SUBDIVISION DRIVEWAY PLAN

OUR REF: 957A as-built redups

TITLE DRIVEWAY PLAN & LONG-SECTION 1 ELANORA ROAD, ELANORA HEIGHTS			
DRAWN JBK	DATE 20 APRIL 2017	CHECKED <i>SbG</i> Sb Civil (Hons) MIE Aust	SCALE @ A1 1:200 1:100

17817-1/C

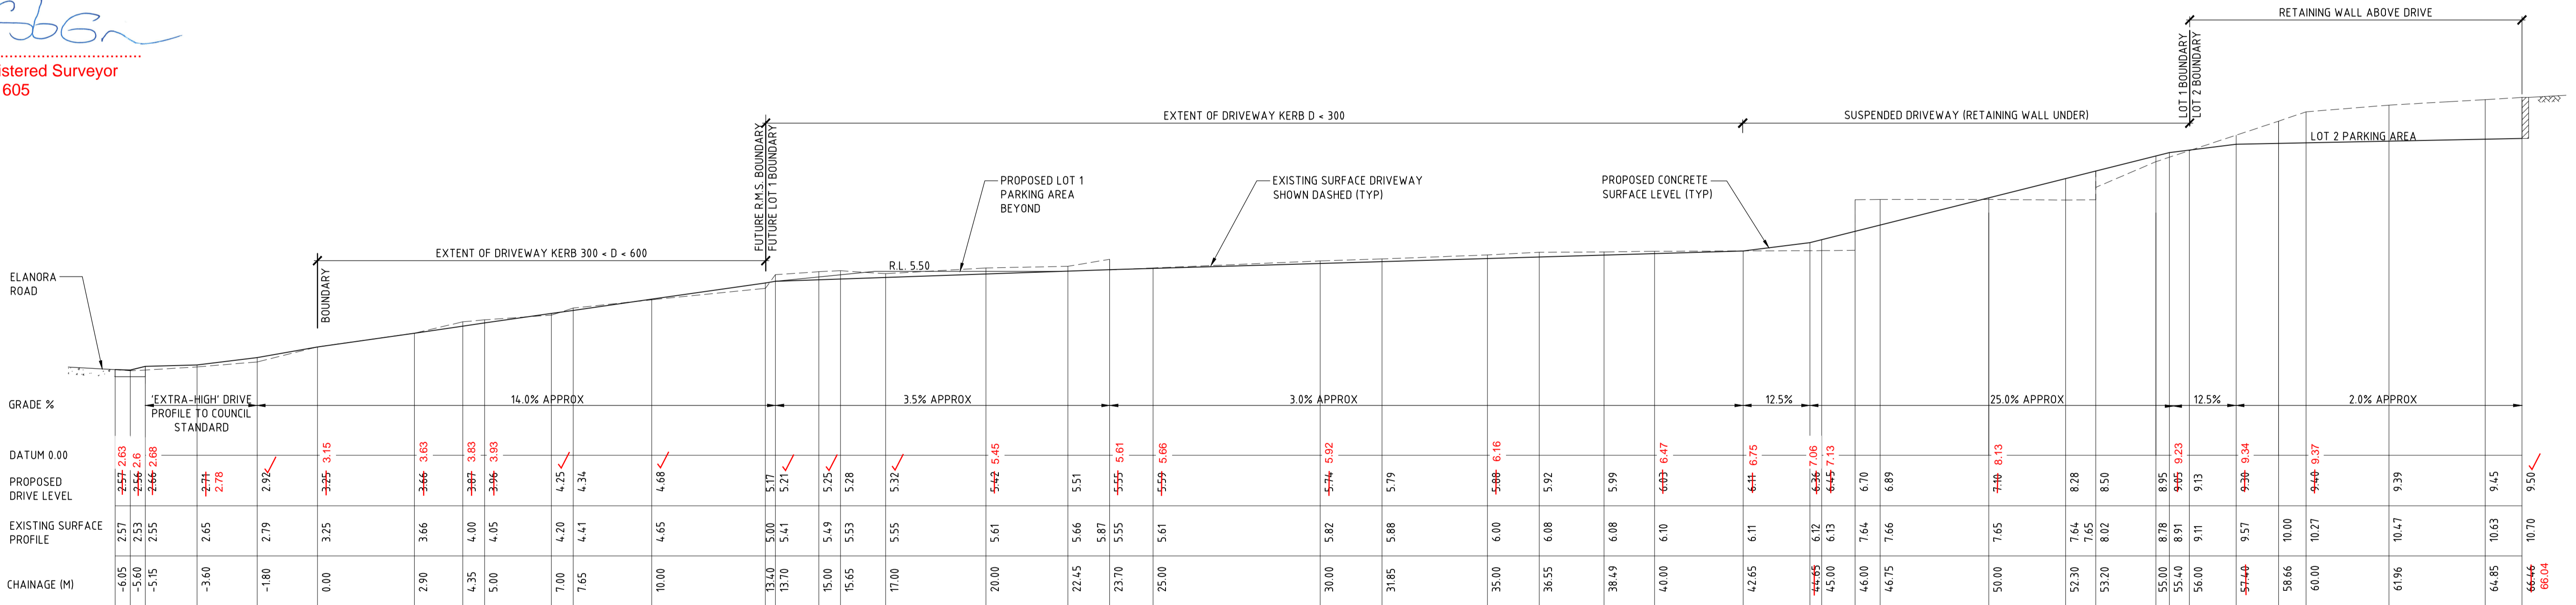
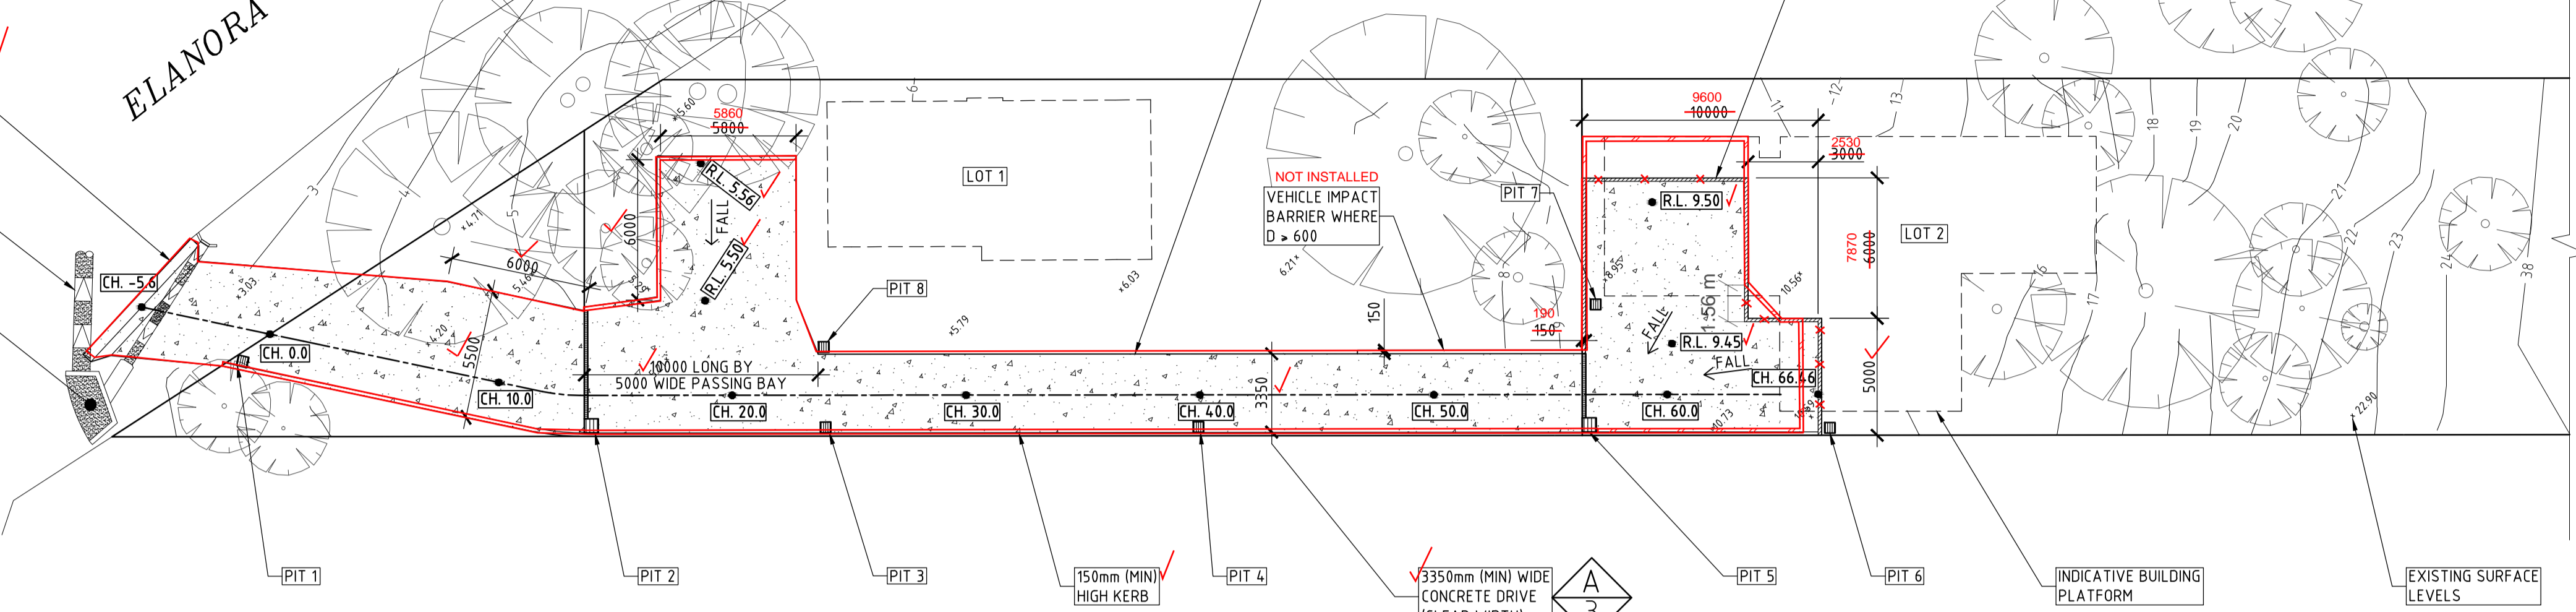
we have attended site on 5-10-17 and as built the newly constructed civil works. we hereby confirm the dimensions, features and levels confirmed hereon in red represents finished works.
